STAFF RECOMMENDATION
3111 Overlook Drive
October 21, 2015

Application: New construction-infill
District: Hillsboro-West End Neighborhood Conservation Zoning Overlay
Council District: 18
Map and Parcel Number: 10410024200
Applicant: Split Rock Development
Project Lead: Paul Hoffman, paul.hoffman@nashville.gov

Description of Project: Applicant proposes to construct a new single-family residence on this vacant lot.

Figure 1. Overhead view of vacant lot at 3111 Overlook.

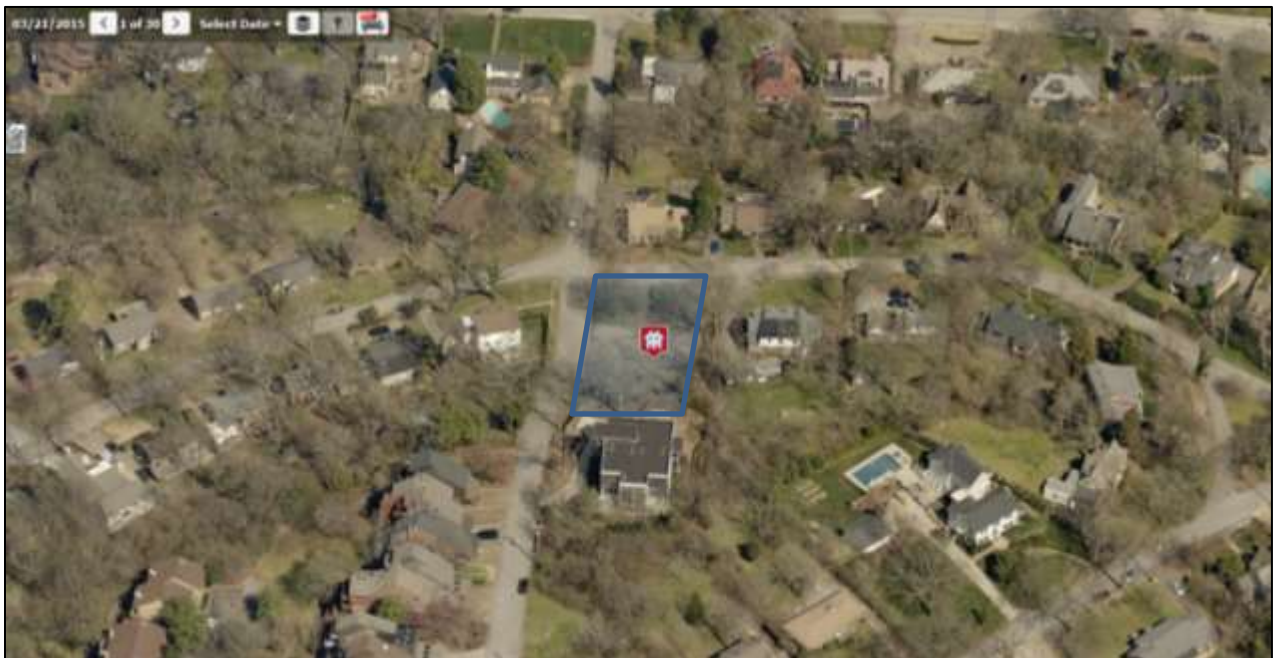
Height & Scale: The new structure's total height will be thirty-one feet (31') from grade. The foundation height is two feet (2'). Several contributing buildings on Overlook Drive and Hillside Drive are as tall as thirty-four feet (34'). The building is eighty feet (80') wide overall in an ell shape. Sprawling homes on larger lots are seen in this portion of the district, characteristic of homes built after World War II. Contributing homes nearby

range in width from forty-two feet (42') to sixty-four feet (64'). Although the proposed building is wider than those dimensions, Staff finds the building is appropriate here, as the lot is very shallow compared to other long lots in the neighborhood, the building area is limited, with significant grade in both the front and rear yards and much of the length is set back from the front wall, between fourteen and twenty-eight feet (14'-28') back. It is also approximately the same width as the previous residence on the site. Staff's analysis is that the project meets section II.B.1.a. and b.

FRONT ELEVATION
 SCALE: 1/4" = 1'-0"

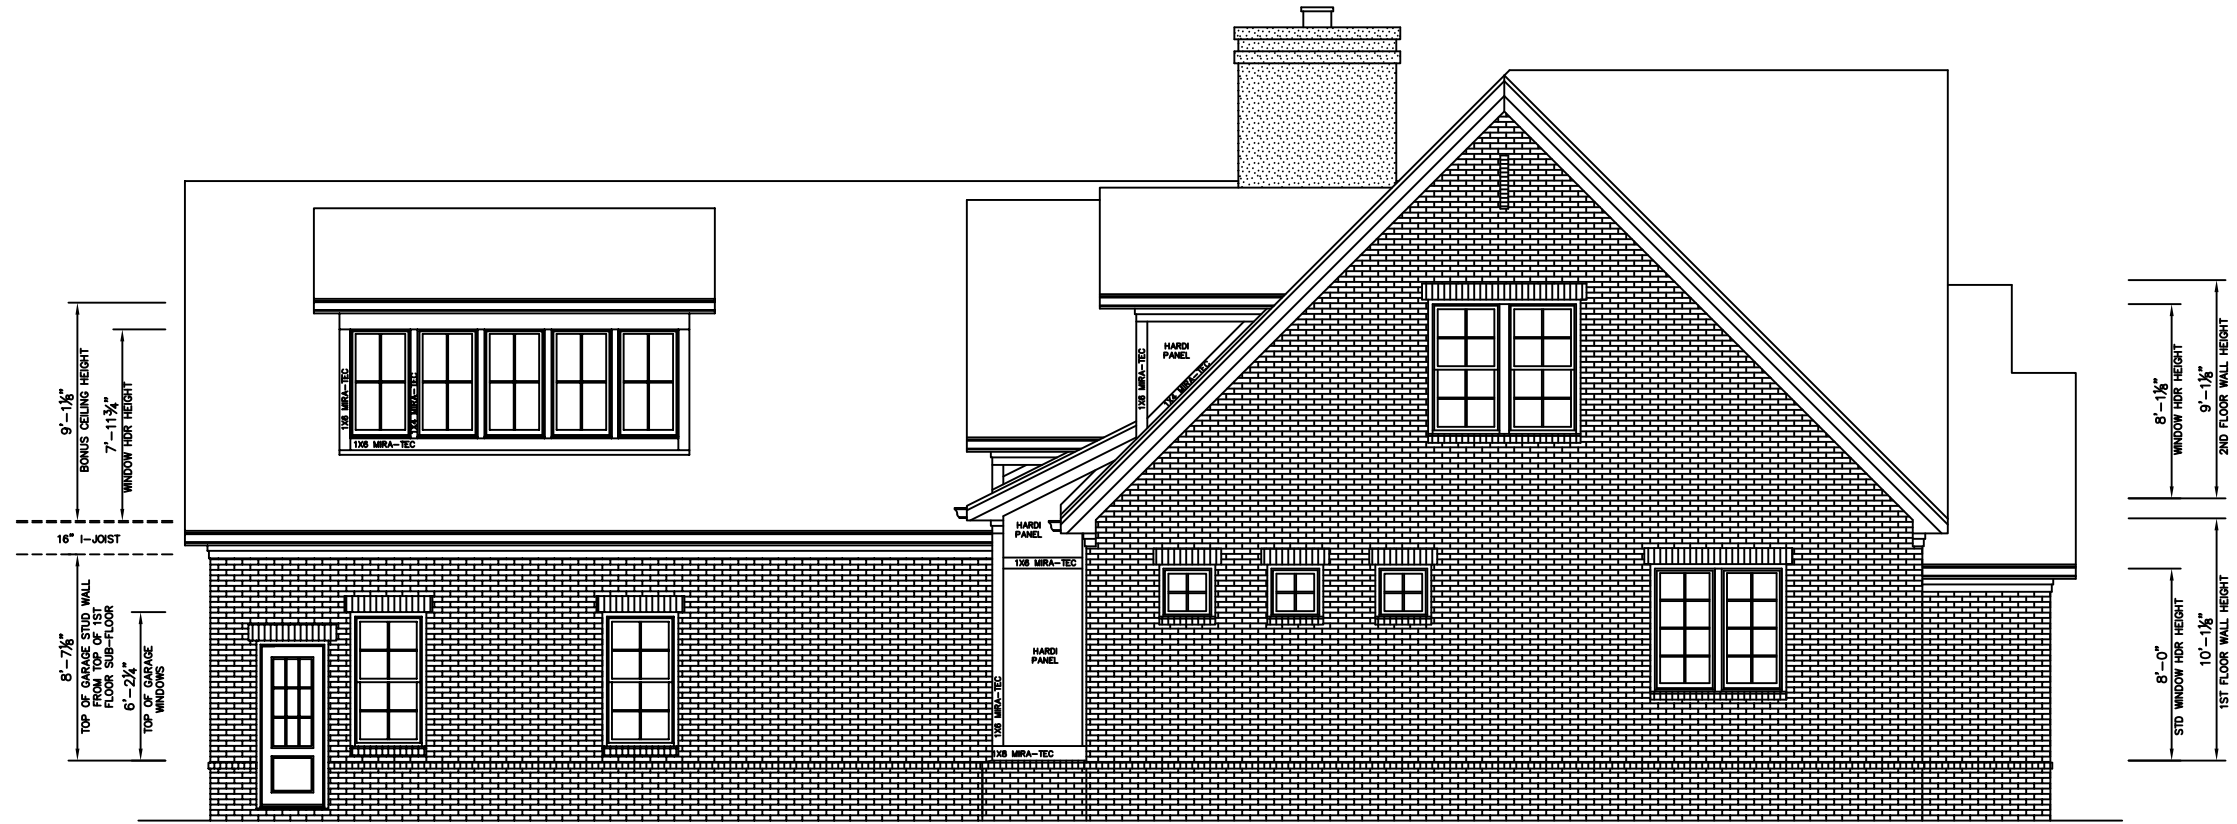
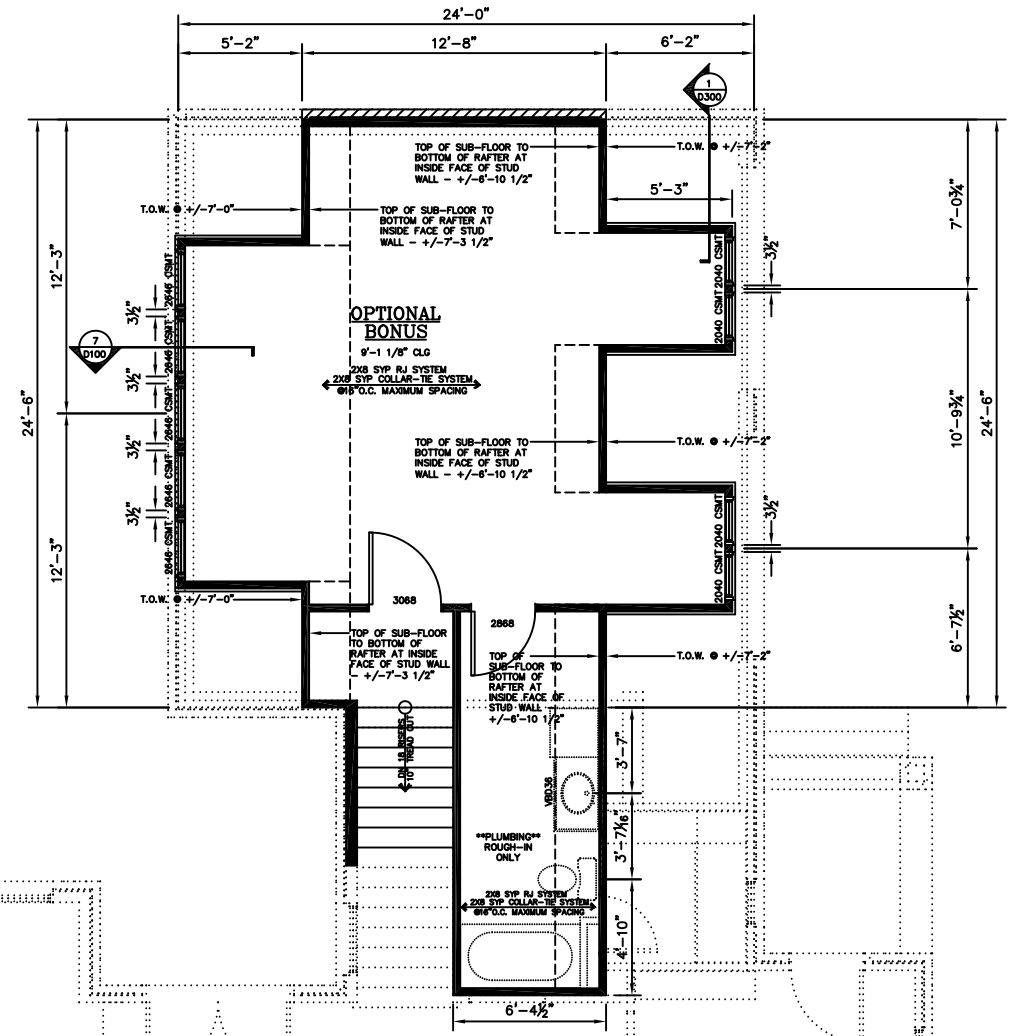
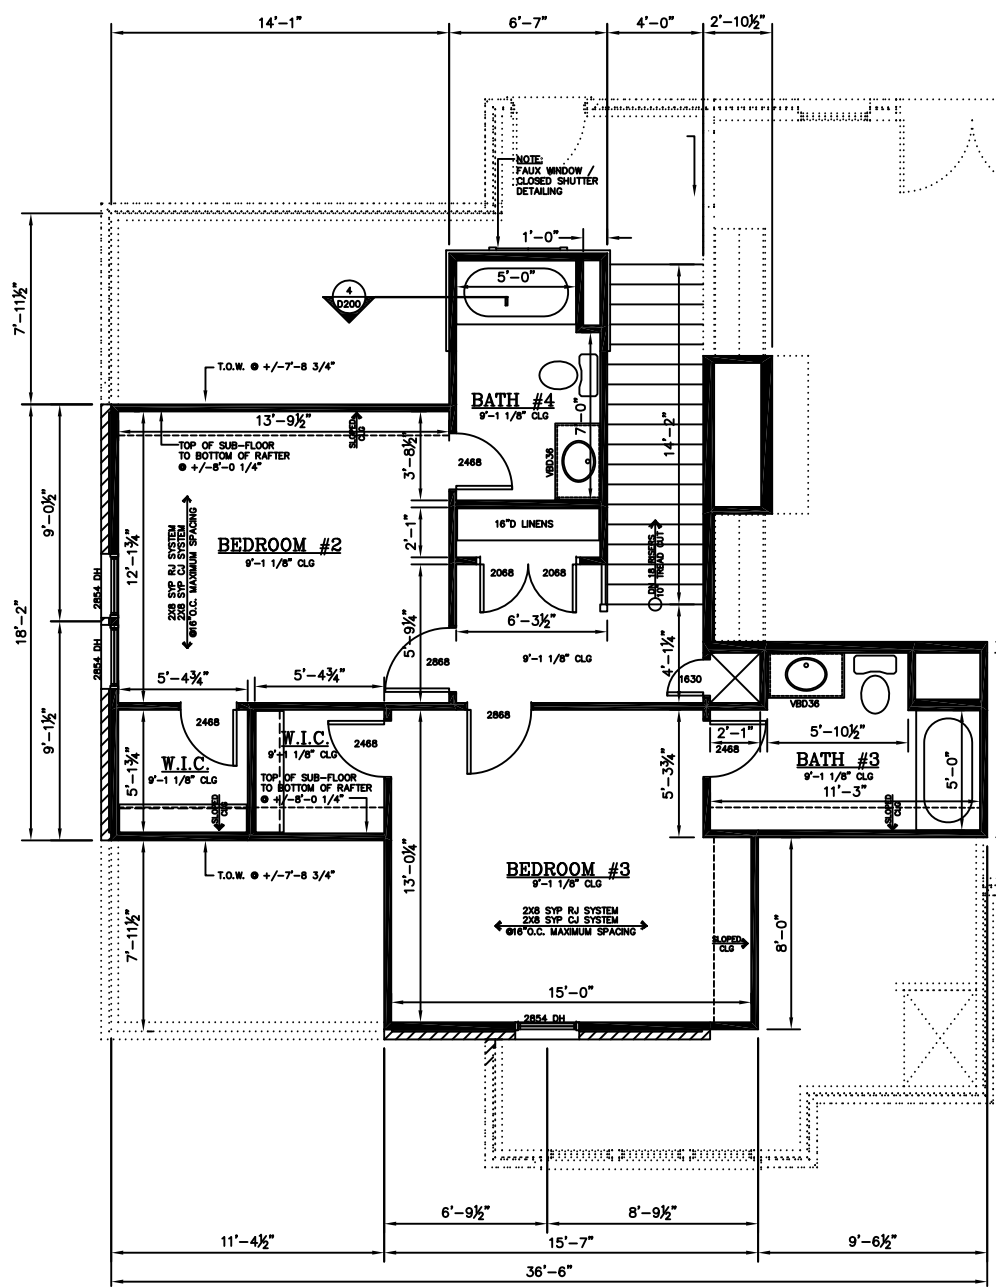
Materials: The new building will be brick. The foundation will also be brick, differentiated from the walls with an alternate course. Staff requests final approval of the masonry, to verify the dimensions, texture and color. The trim will be composite, fiber cement, or wood. The rear and left side will have fiber cement board-and-batten sections. The chimney will have a stucco cladding. The roof will be shingles; Staff recommends administrative approval of the color. The windows and doors were not specified; Staff recommends administrative approval of the windows and doors. The garage doors are two separate doors rather than one large door, as typically requested of multi-bay garages that face a street. With staff's final approval of the masonry, roofing color, windows, doors and garage doors, staff finds that the materials meet section II.B.1.d.

Roof form: The house is cross-gabled; the gables and gabled dormers all have 12/12 pitch. Shed dormers on the front and left side have 4/12 pitch. Staff finds that the proposed roof form will not contrast greatly with those of surrounding historic buildings. The project meets section II.B.1.e.

Proportion and Rhythm of Openings: The windows are generally twice as tall as they are wide, thereby meeting the historic proportions of openings. Paired windows have the four to six inch (4-6") mullion typically requested by the Commission. The largest expanse of wall space without a window or door opening is twenty-four feet (24'). As this is on the rear wall of the garage, its visibility will be minimal. Staff finds the project's proportion and rhythm of openings to meet Section II.B.1.g.

Appurtenances & Utilities: The location of the HVAC and other utilities was not noted. Staff recommends that the HVAC be located on the rear façade, or on a side façade beyond the midpoint of the house, to minimize their visibility from the street. With this condition, the project will meet section II.B.1. i.

1. The finished floor height shall be consistent with the finished floor heights of the adjacent historic houses, to be verified by MHZC staff in the field;
2. Staff approve the final details, dimensions and materials of windows, doors and garage doors prior to purchase and installation;
3. The HVAC shall be located behind the house or on either side, beyond the mid-point of the house;
4. Staff approve the roof color and masonry color, dimensions and texture.
